RE: 2019 Inspection of Conowingo Fish Passage Facilities

Subject: Inspection of Fishways at Conowingo Hydroelectric Project (FERC #405) on May 23, 2019

Figure 1 - Exclusion screen in down position during fishing mode

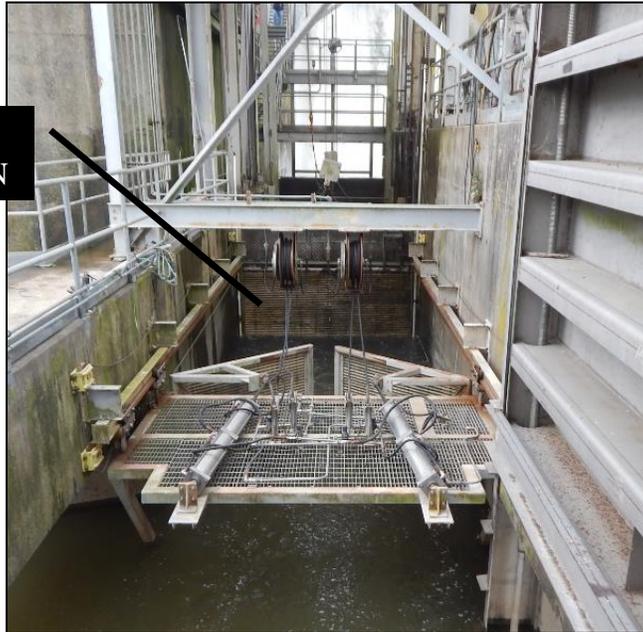
- Screen position during fishing mode - A fish exclusion screen on the downstream boundary of the hopper, designed to keep fish inside the hopper while this one is hoisted up, it's being intentionally operated in a way to keep fish from entering the area over the hopper, even during periods of "fishing mode" (Figure 1). Normally, during the fishing mode operation of a fish lift, the fish crowding mechanisms should be attempting to accumulate as many fish as possible within its holding pool/hopper area. Excluding fish from entering the area over the hopper essentially reduces the holding pool estimated capacity and could potentially become a bottleneck for the overall biological capacity of the EFL. The Service requests further discussion about the strategic choice to operate this screen in this manner.

Figure 2 - Eel pass attraction flow entering the eel ramp vertically

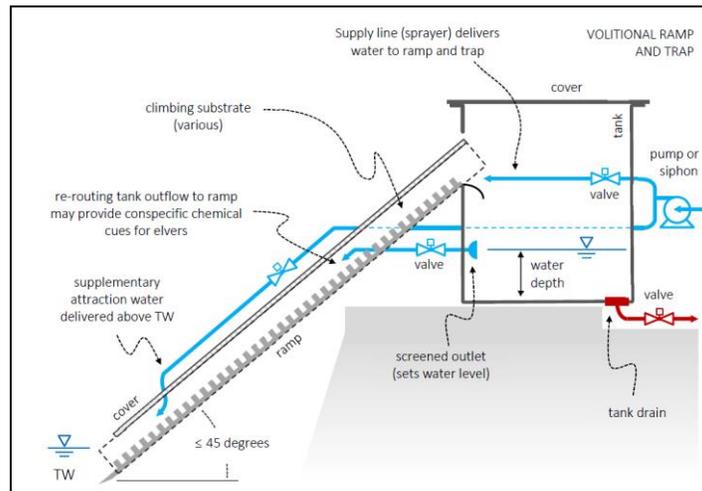
- Attraction flow enters the eel pass vertically - Service personnel noticed that the existing eel pass, located on the western river bank in the tailrace, currently introduces its attraction flow through a gravity-fed water line that discharges flow vertically above the apex of the eel ramp, near its exit (Figure 2). Traditional eel passes are typically designed to provide attraction flow through a pump-fed system, and introduce the attraction flow horizontally at the exit of the eel ramp, somewhere upstream of the apex (Figure 3). The goal of this recommended configuration is to hone into the migrating eels' motivation to move in an upstream direction, specifically at the moment when they'd be required to overcome the apex of the eel ramp. The Service believes that a closer look at eel behavior near and around the apex of the Conowingo's eel pass is warranted. Any eel reluctance or failure to move over the apex should be noted, and a different attraction flow system could be considered.
